# RIVERSIDE ENERGY PARK DCO

LB Bexley Deadline 3 Submissions

18 June 2019

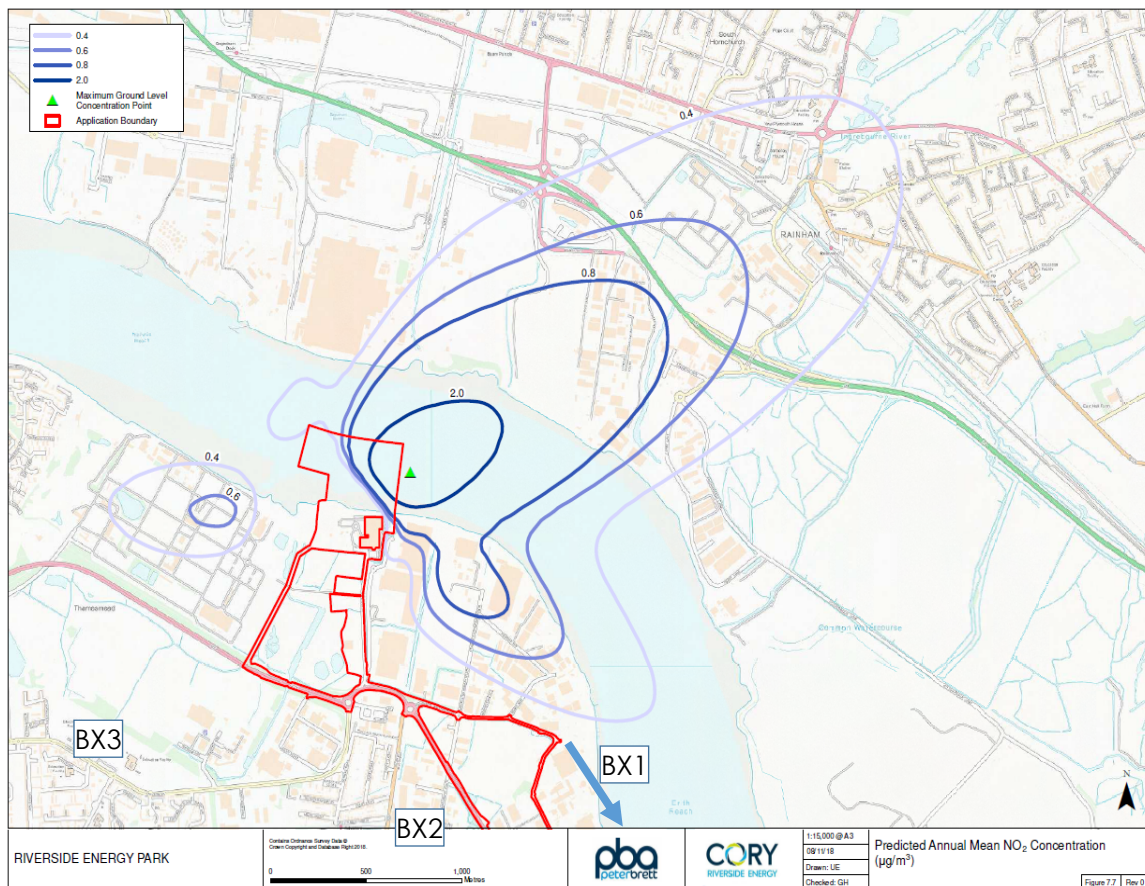
- 3.8 LBB currently carries out monitoring at three locations in the vicinity of the existing RRRF and proposed REP:
- BX1 Whitehall Lane, Slade Green
  - BX2 Belvedere Primary School, Mitchell Close
  - BX3 Harris Garrard Academy, Yarnton Way
- 3.9 Monitoring stations BX2 and BX3 are closest to the proposed REP, and are shown superimposed on Environmental Statement Figure 7.7 below.

- The proposed REP facility displays a different range of impacts due to process and traffic emissions than the existing RRRF plant. The figure above shows the forecast dispersion pattern of the proposed REP facility. In view of this, LBB may wish to relocate one of its monitoring stations, or add an additional station, to measure pollution levels associated with the proposed REP.

- 3.12 LBB therefore requests funding to enable the existing BX1 and BX2 stations to continue operating. LBB may also request funding to relocate monitoring station BX2, and/or to set up an additional monitoring station.
